PCN

AO-PCN-2026-014-S

Reel quantity reduction from 10K to 5K standardization for TCS3410X, TMD26353, TMD27123, TSL2511X, TSL252XX.

15.02.2026

Reason for change:

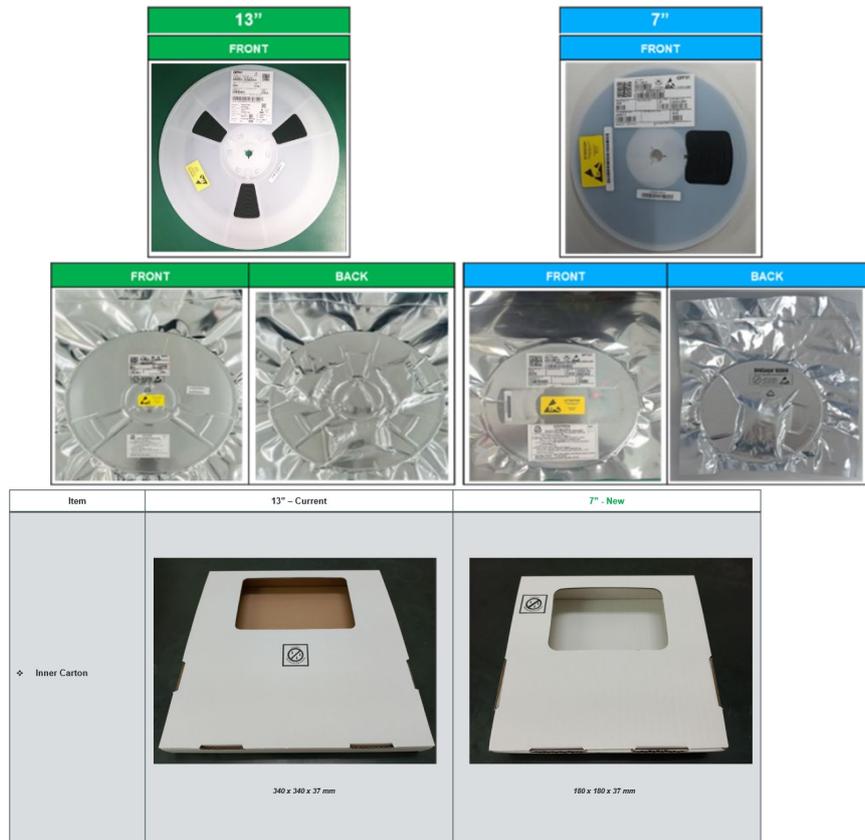
This is in line with the sticky tape issue encountered by the customer, the investigation determined factors of the said issue. Tribocharging and “nesting effect” are some of the factors identified. Corrective actions to address this issue are deeper Ko, narrow pocket dimensions (Ao and Bo), and reel quantity reduction.
